# Product Change Notification

Date Issued :	May 09, 2023	PCN Number :	513629
Reason for Change :	Capacity change or tool replacement Packaging Method/Quantity Changing Manufacturing Process Change (Molex)		
Description of Change :	Molex plans to develop the 4-cavity shell mold, develop the point plating station, and establish a new automated production line to meet the demand. The product design will not change, but the packaging method on the assembly line will be different.		
Assessment of Change :	First Article Inspection		
Planned Implementation Date :	March 15, 2024		
Sample Availability Date:	January 15, 2024		
Internal Molex Qualification Date :	January 30, 2024		
Last date to request Samples by Customer :	January 01, 2024		
Traceability Code Markings / Date :	Lot information on label

## Power plane Vertical and Right Angel Products

After Picture

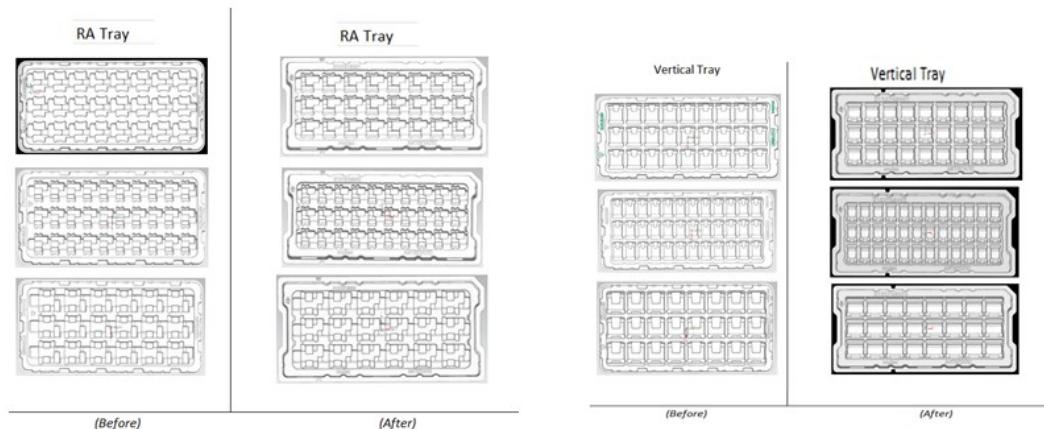
- Change Description: The packing method is the same except for the change on the edge of the Tray. (The automation line qualify, will use the new packing tray for shipment.)
